Townson Road Upgrade between Richmond Road and Jersey Road – Stage 1

Submissions report

Transport for NSW | September 2021

Figure 3.1: Change in compound site location

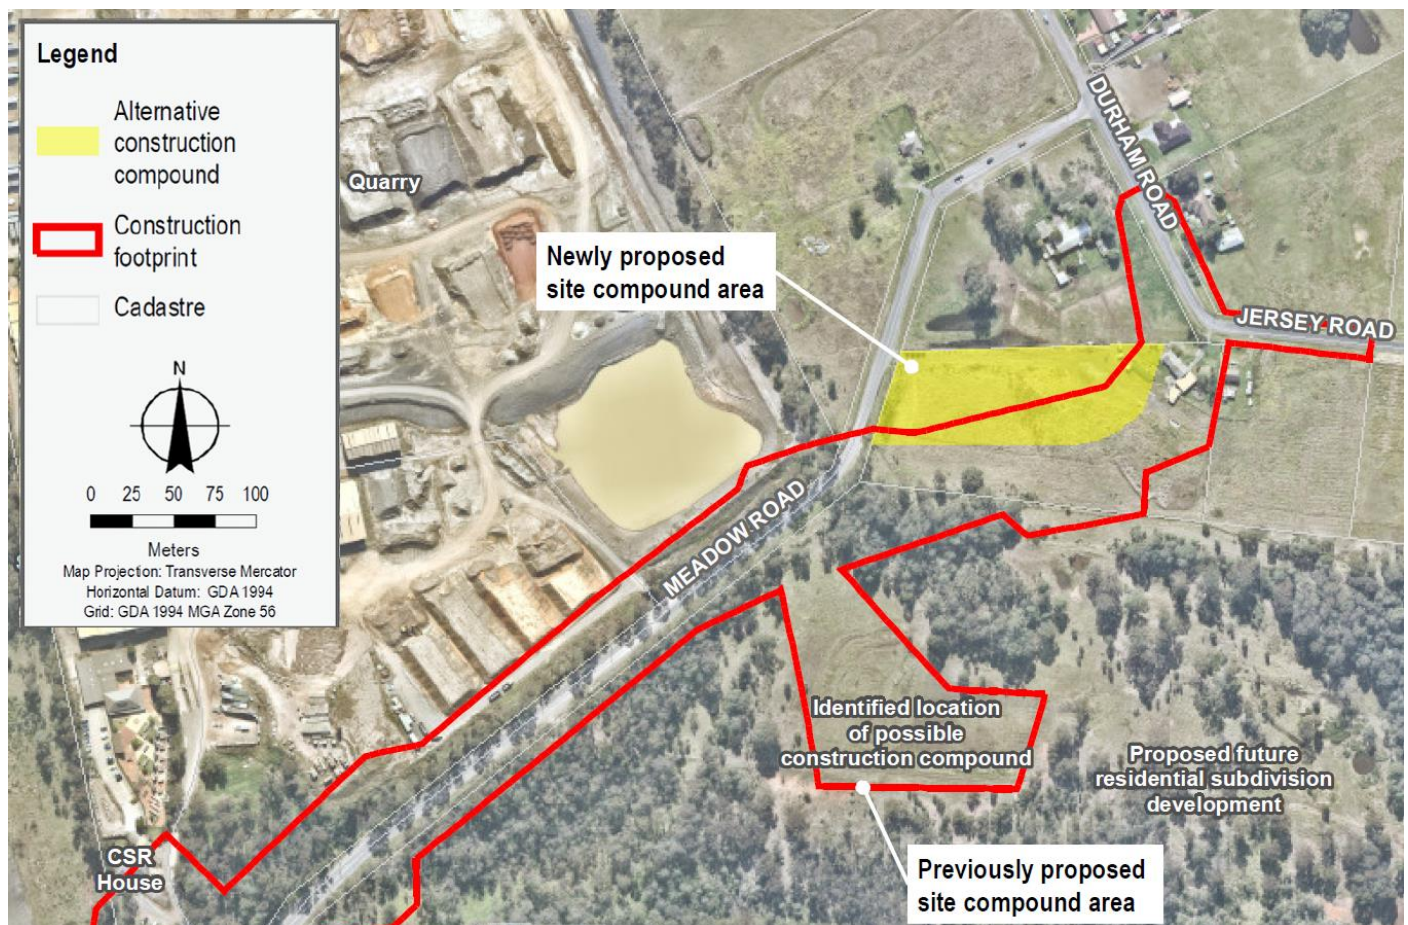
The location of the former and new compound site is shown in Figure 3.1.

This change is required following further consultation with the property owner, which confirmed the original location would not be available at the time of construction. The new site is owned by the same property owner who proposed this location as an alternative site. This site is also within a property already partially impacted by construction of the proposal.

Part of this site is outside of the exhibited construction footprint and would therefore require additional temporary leasing.

Figure 3.2: Temporary access road on Townson Road

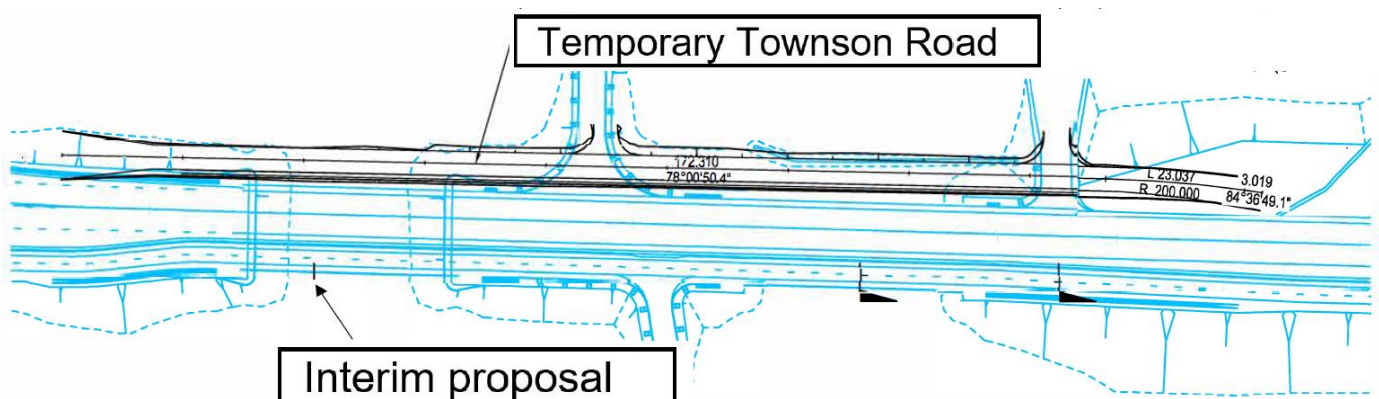
Following receipt of submissions on the REF, the construction stage of the proposal has been refined to enable Townson Road to remain open throughout the construction period for local traffic. Blacktown City Council also requested an option which would maintain a through route along Townson Road which would avoid the need to use the alternative Victory Road and Alderton Drive detour. An additional access provision was therefore investigated to provide and maintain temporary access along Townson Road during construction of Bells Creek Bridge and the flood relief bridge.

Figure 3.2 shows a temporary access road would be provided along the northern boundary of the construction works to maintain access to the Nursery and the CSR Brickworks site and provide a through route.

This road will comprise a single traffic controlled lane, either signalised or with a traffic controller. This will provide two property access points into the Nursery. It will connect into the existing Townson Road at either end, allowing trucks from CSR and other through traffic access along the Townson Road corridor. This road will be operational for around 6 months during construction of Bells Creek Bridge and the flood relief bridge.

Figure 3.3 Revised interim proposal

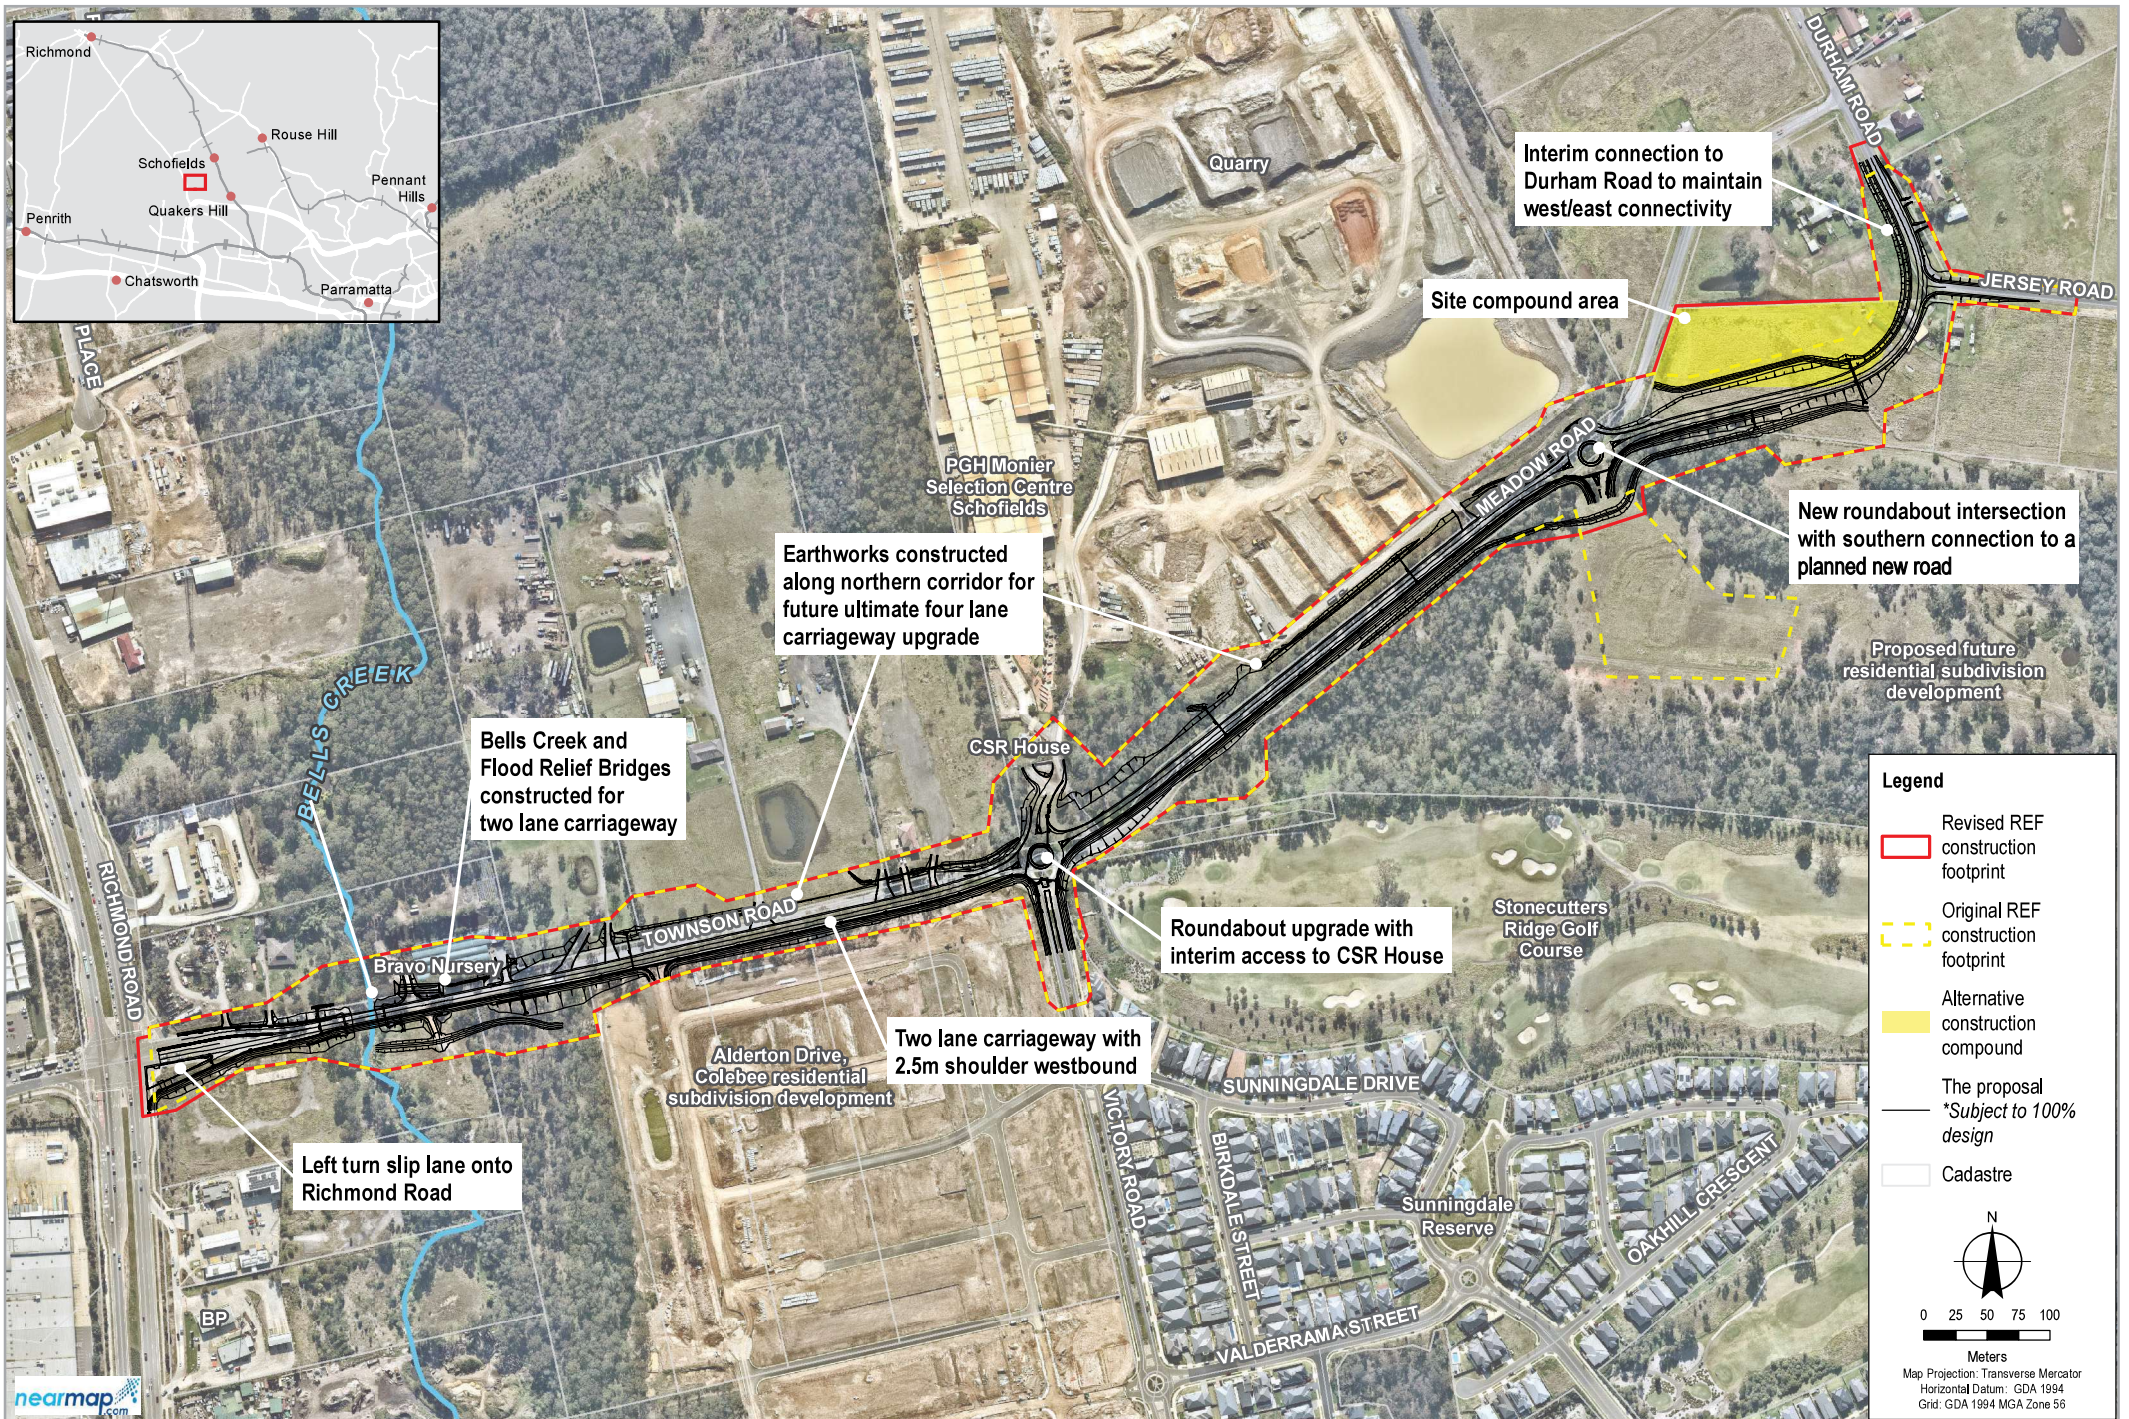
A minor change to the construction footprint is required at both the eastern Richmond Road end and north-western Durham Road end, of the proposal. This work would comprise minor adjustments to the level of the existing roads in order to tie-in the proposal to the existing road carriageways and associated utility adjustments. This work is within the existing road corridor of Richmond Road to the west and Jersey Road to the east. No additional land acquisition is required.

Another minor change to the construction boundary is required on the south side of the proposal around the planned new road. This is to accommodate construction of a drainage channel.

The changes are shown in Figure 3.3 which shows the footprint from the exhibited REF and the new construction footprint.

Additional design refinements since display of the REF have identified the need for two additional accesses for Durham Road 61 and 61B to be provided. These are located within the construction footprint of the REF and do not require any further property acquisition. Adjustments comprise minor changes to the levels of existing access to tie-in with the upgraded carriageway. Property adjustment plans would be developed in consultation with the affected property owners.

Figure 4.1 Changes to biodiversity impacts

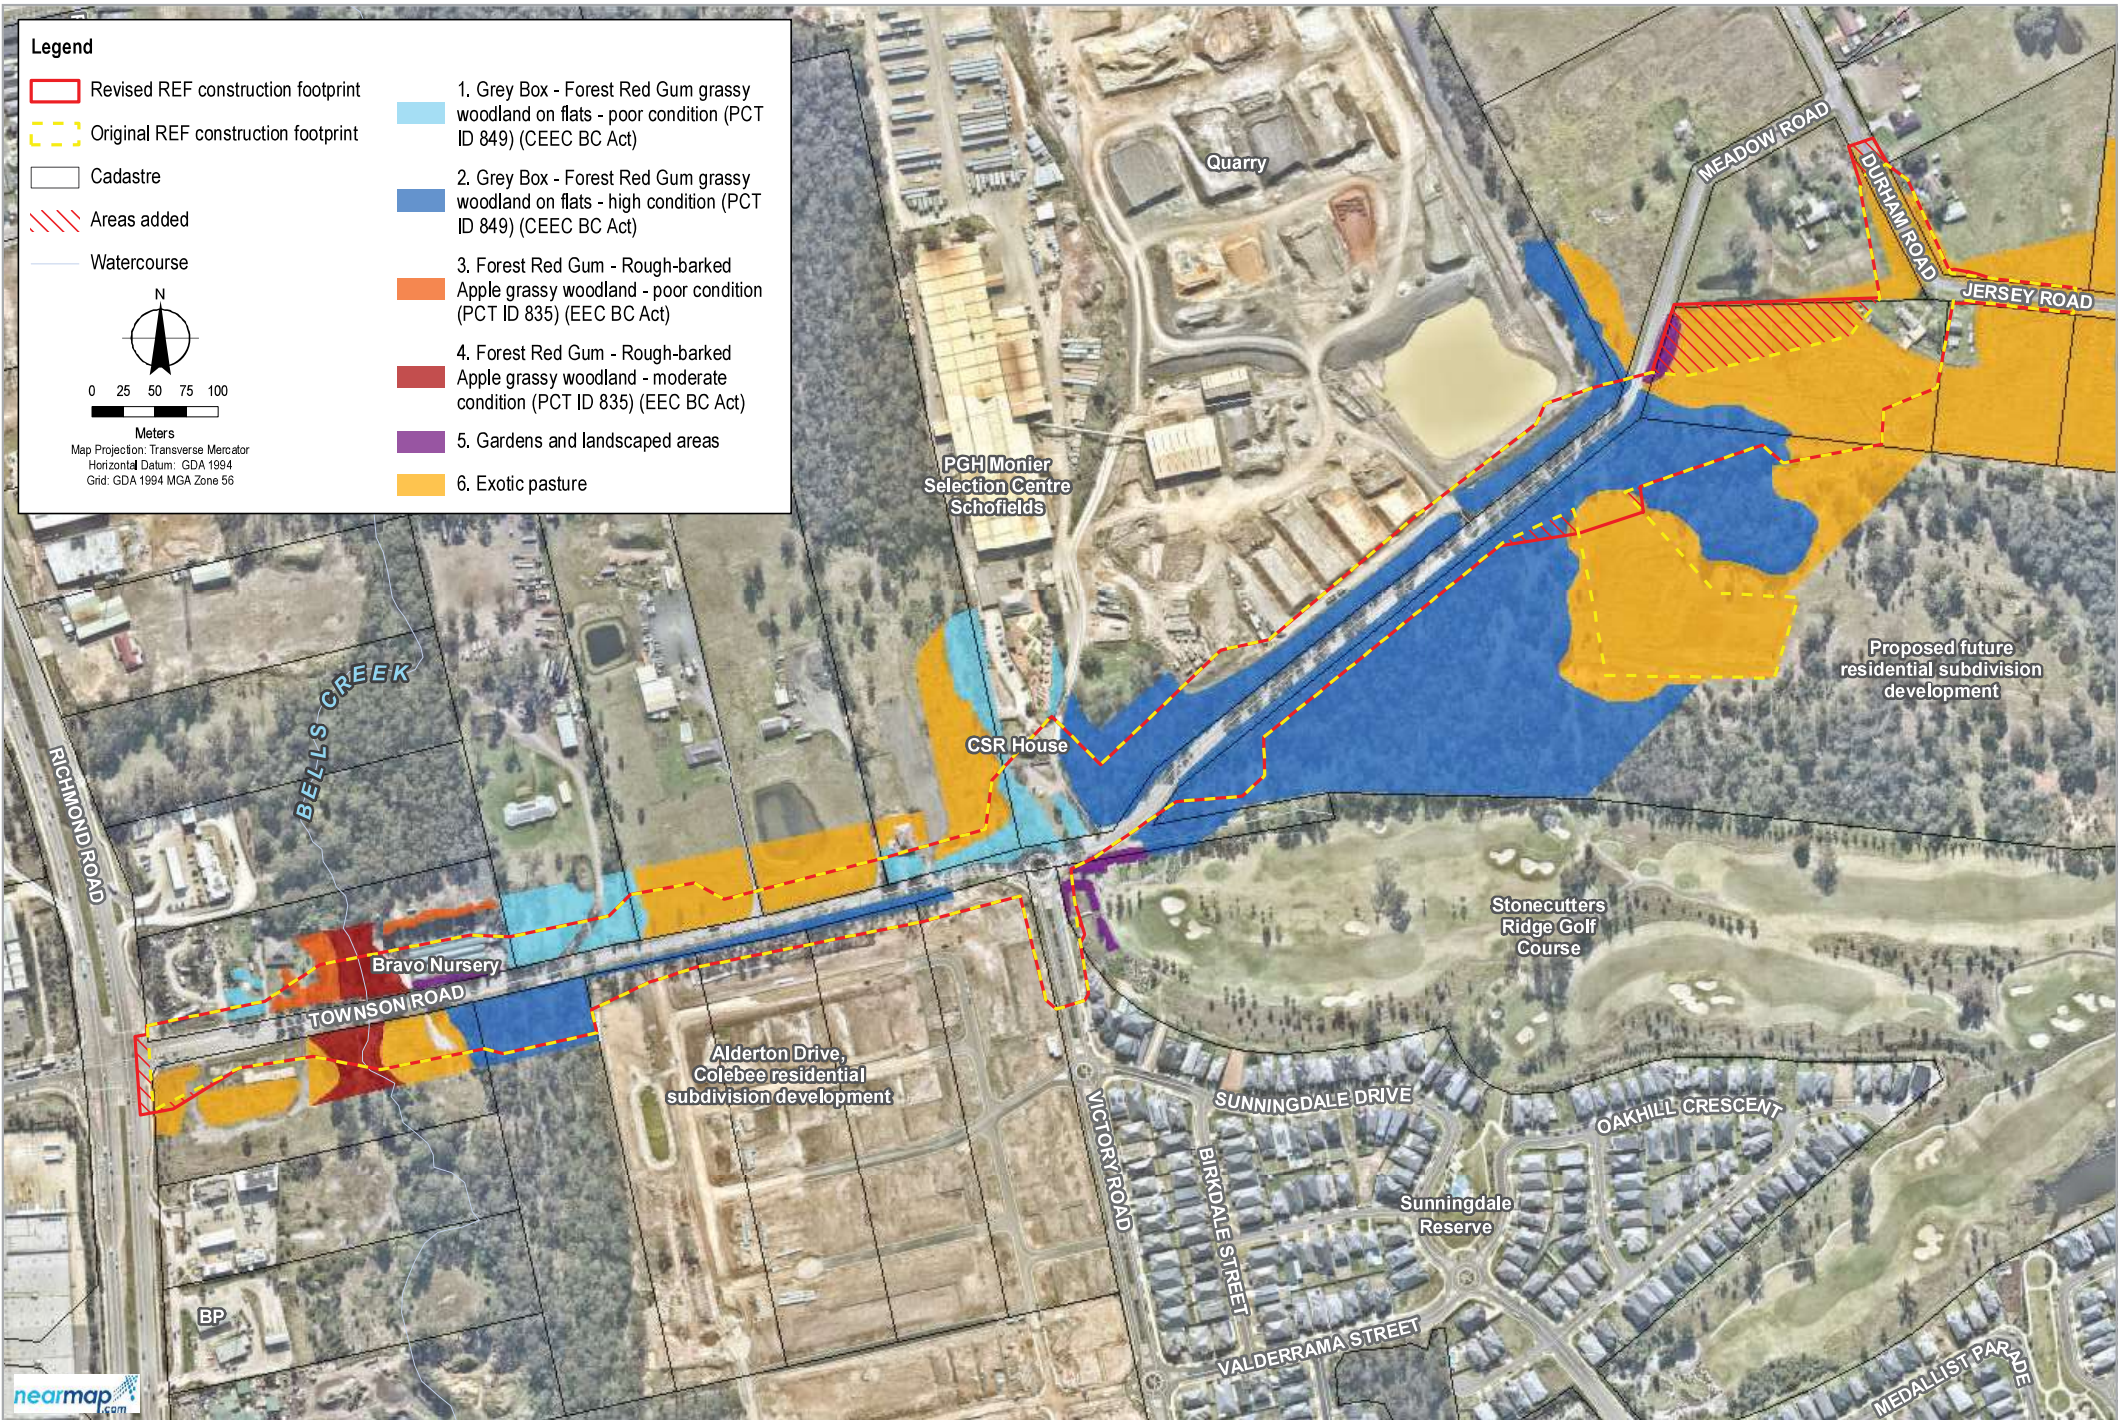
An additional area of Cumberland Plain Woodland would be impacted by the expansion of the construction footprint next to the intersection for the new planned road. This area comprises 0.06 hectares (ha) and is within certified land. There are no additional impact predicted to habitat for threatened flora are identified. The details of additional vegetation impacted are presented in Table 4.2 and shown on Figure 4.1.
